ENGINE - LP COMPRESSOR - DELETION OF SILVER PLATING ON THE LPC INTERMEDIATE CASE MODULE  
ATTACHING BOLTS - CATEGORY CODE 6 - MOD.ENG-72-0247

V2500-ENG-72-0247

Install the LPC Intermediate Case Module Attaching Bolts  
Fig.1

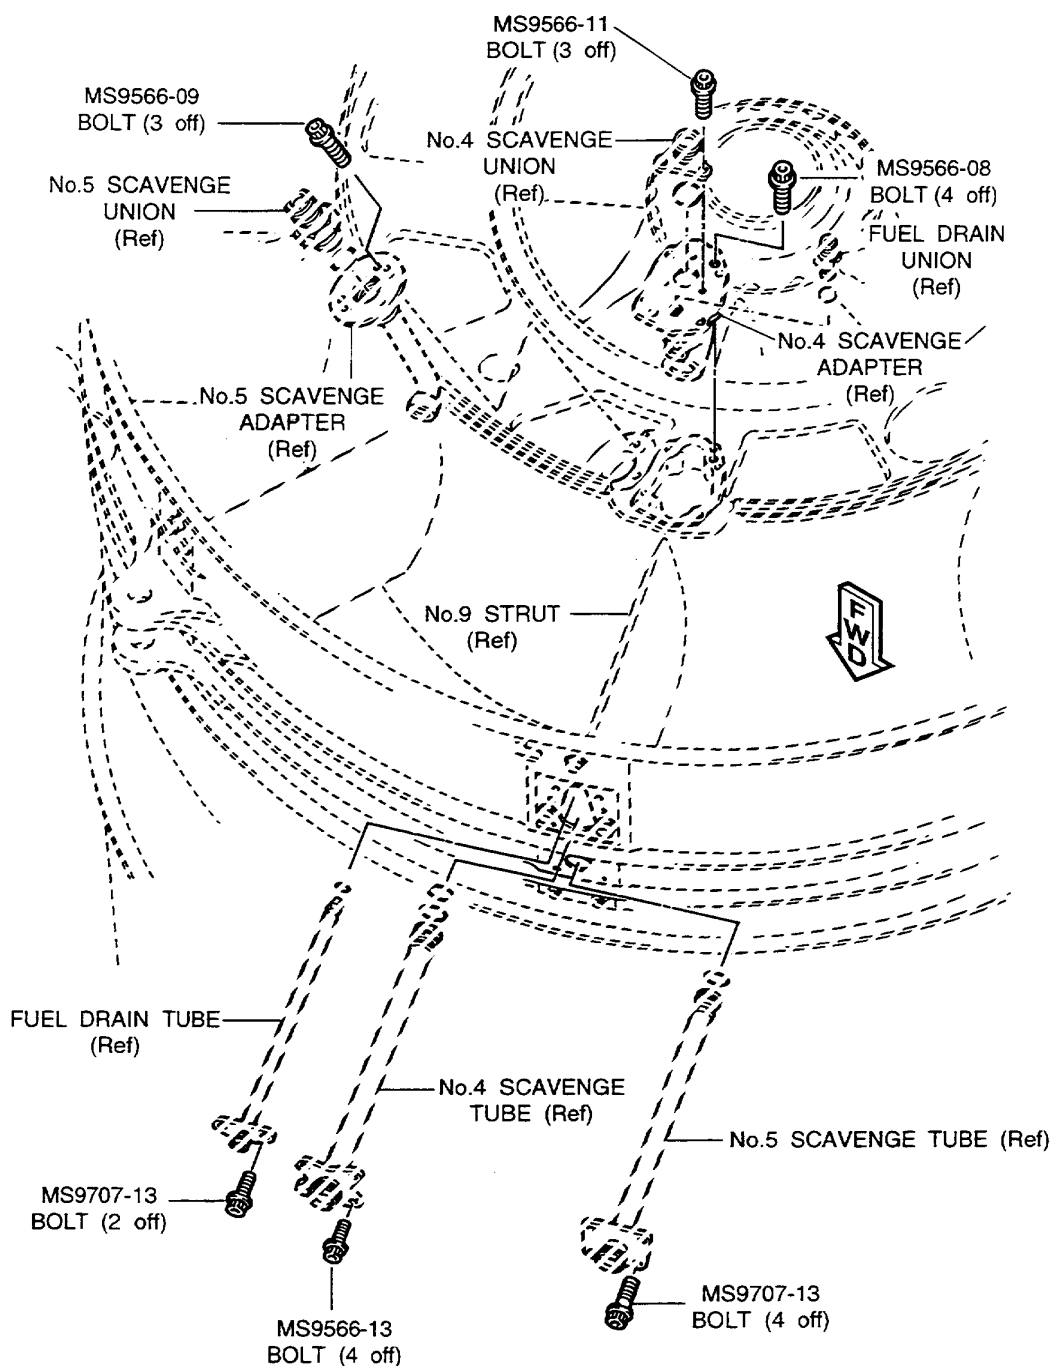
The existing bolts which secure the No.4 and No.5 scavenge tubes, the No.4 and No.5 scavenge adapters, the fuel drain tube and the No.4 scavenge union are plated by silver on the threaded area. This silver plating impedes the proper installation between bolts and inserts.

It was revealed that the silver plating of the bolts is unsuitable at above locations, because the silver plated bolts and the inserts may turn together when the plated bolts are installed to the fan frame. The insert will be displaced inside the fan frame.

To change silver plated bolt to non-silver plated bolt.

- (1) Provide a non-silver plated bolt which secures the No.4 and No.5 scavenge tubes, the No.4 and No.5 scavenge adapters, the fuel drain tube and the No.4 scavenge union.

- (1) Install the three MS9566-09, Bolts which secure the adapter (72-32-03,01-933) by the approved procedure in Reference (2), Chapter/Section 72-32-00, Assembly-11.

- (2) Install the four MS9566-08, Bolts which secure the adapter (72-32-03,01-920) by the approved procedure in Reference (2), Chapter/Section 72-32-00, Assembly-11.

- (3) Install the three MS9566-11, Bolts which secure the No.4 scavenge union (72-32-03,01-994) by the approved procedure in Reference (2), Chapter/Section 72-32-00, Assembly-11.

- (4) Install the two MS9707-13, Bolts which secure the fuel drain tube (72-32-96,01-300) by the approved procedure in Reference (2), Chapter/Section 72-32-00, Assembly-11.

- (5) Install the four MS9566-13, Bolts which secure the No.4 scavenge tube (72-32-96,01-350) by the approved procedure in Reference (2), Chapter/Section 72-32-00, Assembly-11.

- (6) Install the four MS9707-13, Bolts which secure the No.5 scavenge tube (72-32-06,01-400) by the approved procedure in Reference (2), Chapter/Section 72-32-00, Assembly-11.
